GOVERNMENT OF THE DISTRICT OF COLUMBIA
DEPARTMENT OF TRANSPORTATION

MEMORANDUM

SUBJECT: ZC Case No. 15-16 – 680 Rhode Island Avenue NE PUD

Figure 7. Pedestrian Pathways (Source: Applicant)

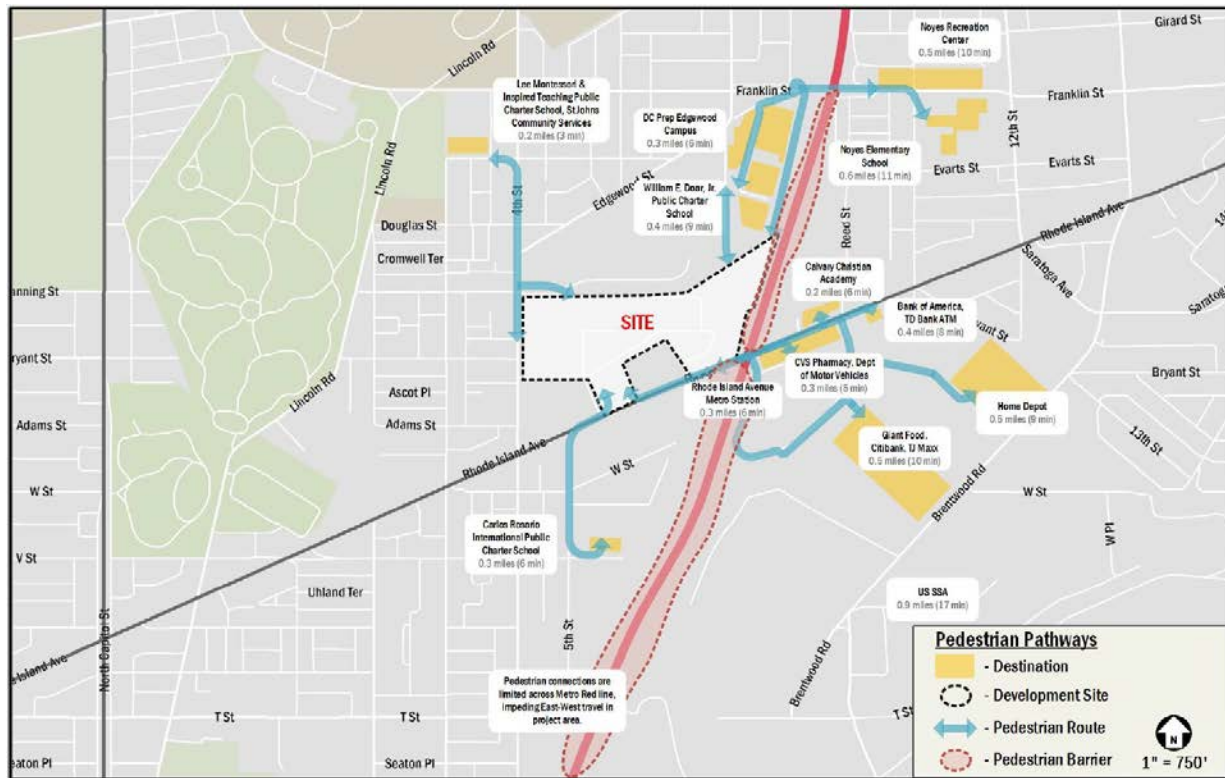
The proposed Site design includes many opportunities to promote walking. New sidewalks that accompany the Site’s street network as well as additional pedestrian connections provided offer excellent pedestrian facilities internal to the Site. The Applicant also performed an inventory of the pedestrian infrastructure in the vicinity and noted any substandard conditions. Improvement to pedestrian routes towards key destinations is pertinent to this project. Potential pedestrian pathways are shown in Figure 4.

As discussed in the Site Access section, the Applicant is expected to work with DDOT through the public space permitting process and/or street dedication process to ensure that pedestrian access points provide safe and convenient Site access, with a focus on connecting to adjacent neighborhoods and connections to major trip production or attraction areas such as the Metro station. DDOT expects the Applicant to meet all DDOT standards for pedestrian facilities. For this development, the Applicant has committed to upgrading any deficient pedestrian facilities along Rhode Island Avenue or 4th Street NE along the site frontage as well as adding pedestrian facilities on all internal streets and new connections to the Metropolitan Branch Trail. This includes approximately 1½ block faces on both Rhode Island Avenue and 4th Street NE and 14 block faces within the PUD. Additionally, the Applicant has committed to providing two pedestrian staircases to provide new connection between this project area and the adjacent Edgewood Commons. DDOT notes that there is an ongoing Rhode Island streetscape study, which is moving into design currently. It will be expected that the Applicant implement this design along Rhode Island Avenue, and any proposals that preclude elements in this design may not be approved.
